# 1978 Corvette: Service Bulletin: Air Conditioning Compressor Noise

**Subject:** Air Conditioning Compressor Noise  
**Model and Year:** 1978 Corvette with RPO L48 Engine and M38 Automatic Transmission  
**Source:** Chevrolet Dealer Service Technical Bulletin  
**Bulletin No:** 78-T-76  
**Section:** Ia  
**Date:** February 1979

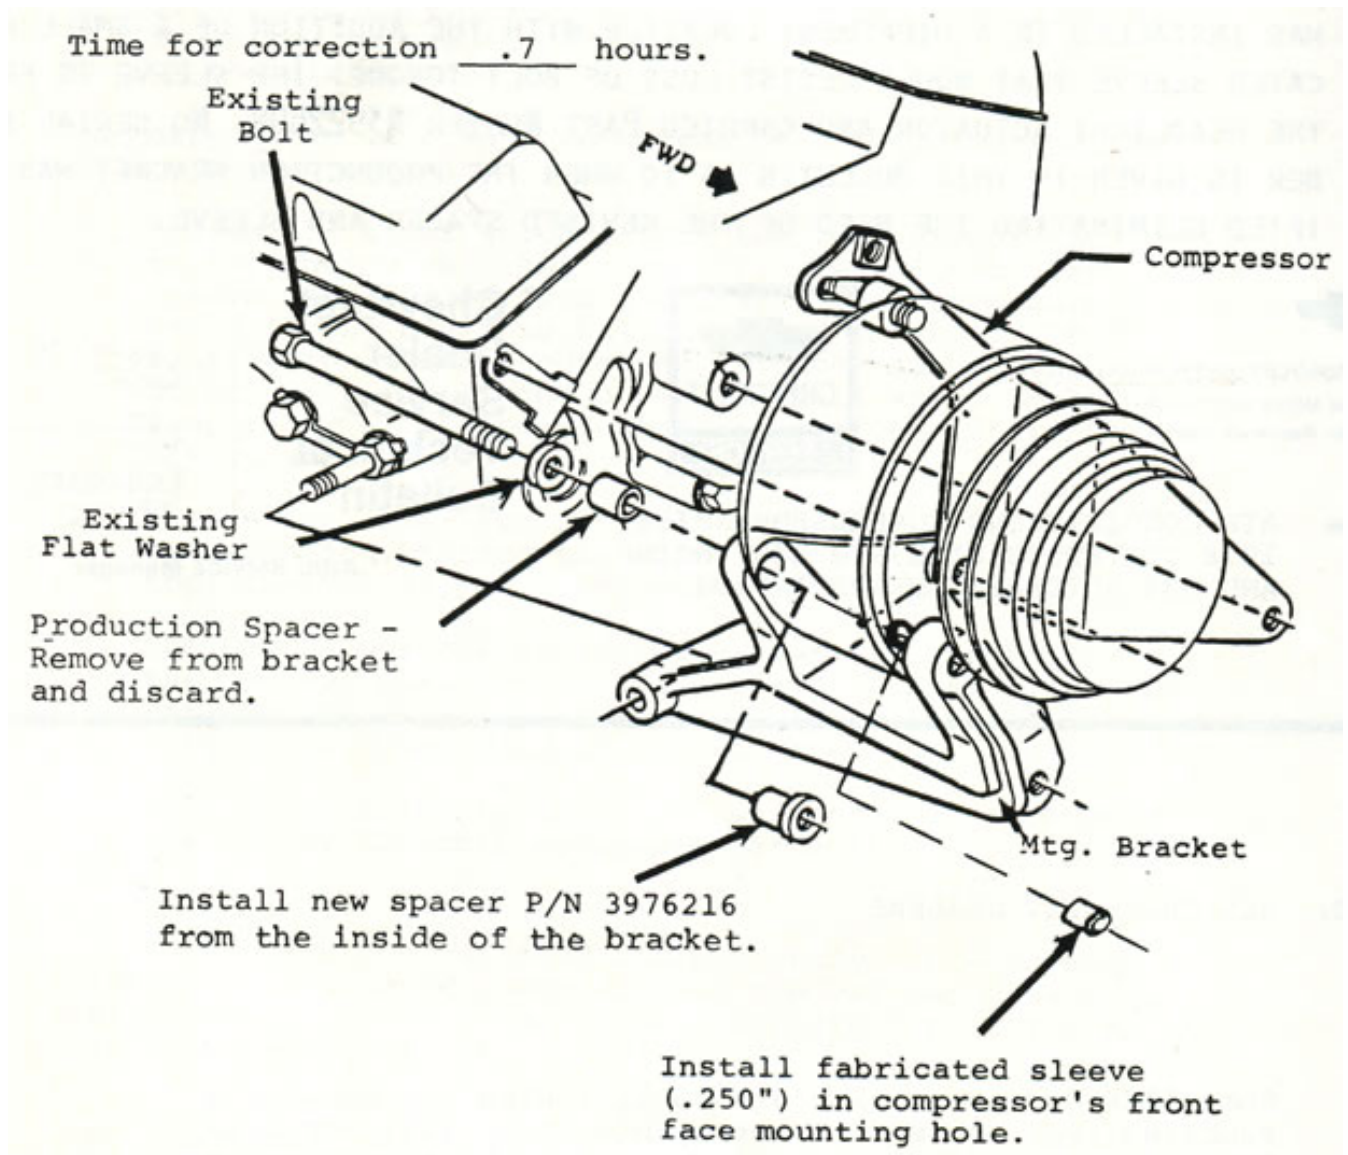
Some 1978 Corvettes with air conditioning may exhibit a rumbling type noise most noticeable at or just off idle RPM, with the air conditioning on, and the transmission in drive.

This condition usually occurs under high ambient temperatures and high head pressured and is caused by a reduction of compressor mounting bolt torque which results in compressor "wobble" and subsequent abnormal deflection of the compressor belt.

In production, the compressor mounting has been revised for 1979 Corvettes. Complaint vehicles can be corrected by using a new mounting bracket spacer, P/N 3976216, and the addition of a sleeve fabricated from a Corvette headlamp actuator sleeve, P/N 3922498, as outlined on page 2.

1. Obtain P/N 3976216 spacer and P/N 3922498 sleeve from stock.

2. Cut the P/N 3922498 plastic sleeve in half, resulting in two .250" long sleeves of which one will be used.
3. Remove the compressor belt and disassemble the compressor from the mounting brackets.
4. Lift compressor from bracket to allow access to both the original spacer in the mounting bracket hole and the mounting hole in the front face of the compressor where the feed-through bolt will exit.
5. Remove original spacer and install new spacer, P/N 3976216 in its place and the fabricated sleeve (.250") in the compressor face mounting hole as shown in Figure 1.
6. Reinstall compressor and belt.
7. Finalize the repair by tightening the compressor belt to 100 +/- 5 lbs. and torquing the compressor mounting bolts to 30 ft. lbs.
